## Addendum 52 – UN Regulation No. 53

### Revision 4 – Amendment 3

03 series of amendments – Date of entry into force: 29 May 2020

**Uniform provisions concerning the approval of category L<sub>3</sub> vehicles  
with regard to the installation of lighting and light-signalling devices**

#### **Model A**

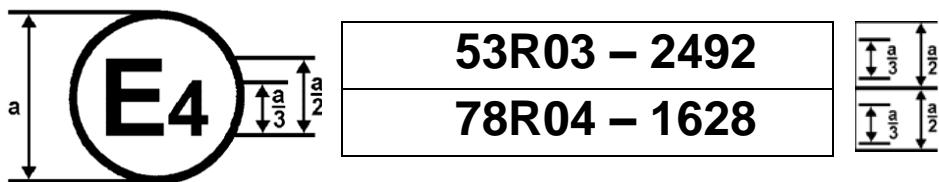
*Annex 2, amend to read:*

The above approval mark affixed to a motorcycle shows that the vehicle type concerned has, with regard to the installation of lighting and light-signalling devices, been

approved in the Netherlands (E 4), pursuant to UN Regulation No. 53, as amended by the 03 series of amendments. The approval number indicates that the approval was granted in accordance with the requirements of UN Regulation No. 53.
